Exhibit "E"

2012 International Residential Code

The following sections, paragraphs, and sentences of the *2012 International Residential Code* are hereby amended as follows: Standard type is text from the IRC. Underlined type is text inserted. ~~Lined through type is deleted text from IRC.~~

Figure R602.6.1; delete the figure and insert the following figure:

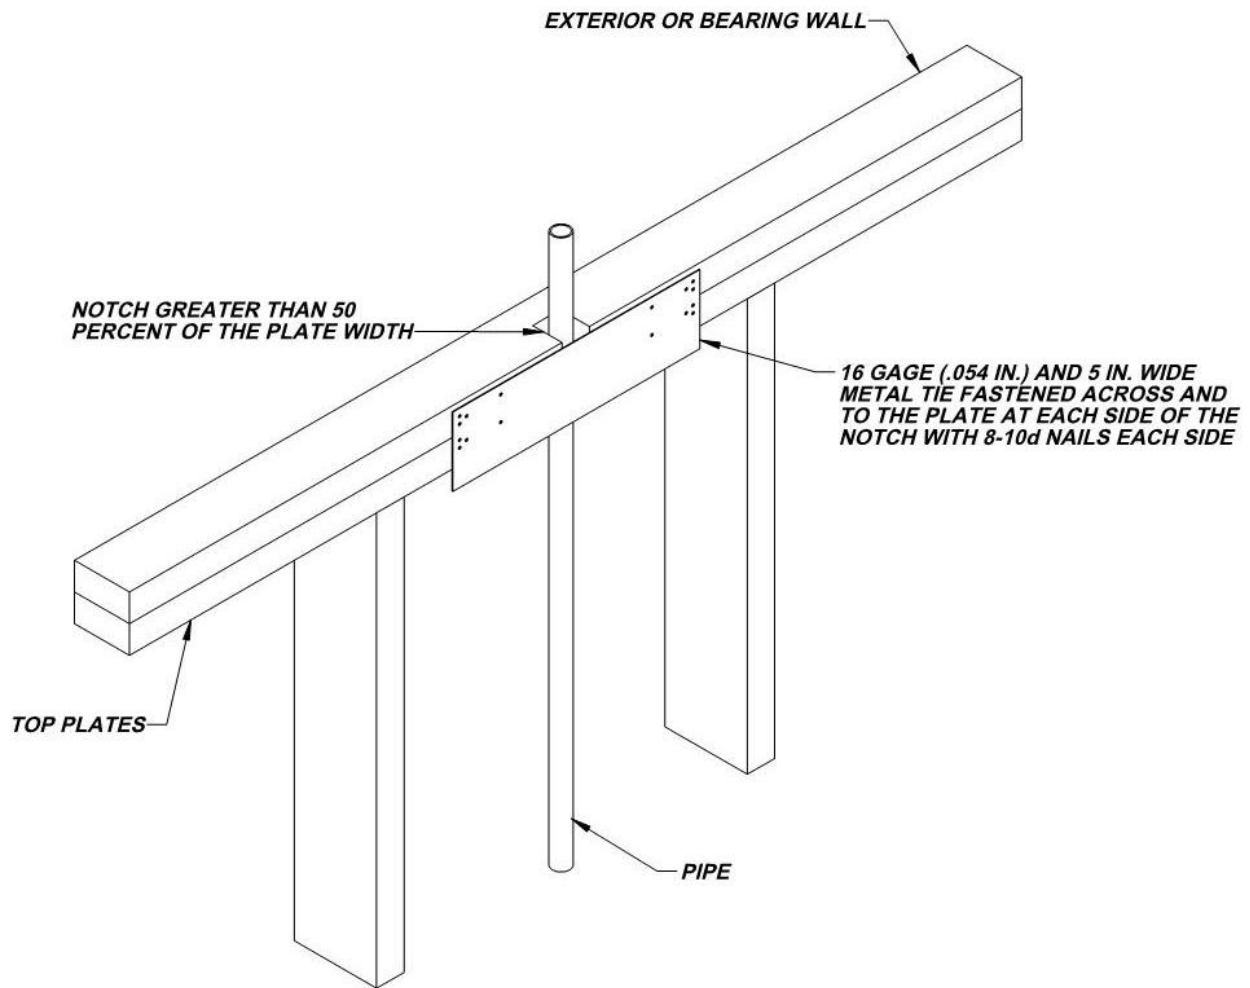
R602.6.1 Drilling and notching of top plate. When piping or ductwork is placed in or partly in an exterior wall or interior load-bearing wall, necessitating cutting, drilling or notching of the top plate by more than 50 percent of its width, a galvanized metal tie not less than 0.054 inch thick (1.37 mm) (16 Ga) and ~~4 ½ inches (38 mm)~~ 5 inches (127 mm) wide shall be fastened across and to the plate at each side of the opening with not less than eight 10d (0.148 inch diameter) having a minimum length of 1 ½ inches (38 mm) at each side or equivalent. Fasteners will be offset to prevent splitting of the top plate material. The metal tie must extend a minimum of 6 inches past the opening. See figure R602.6.1. {remainder unchanged}
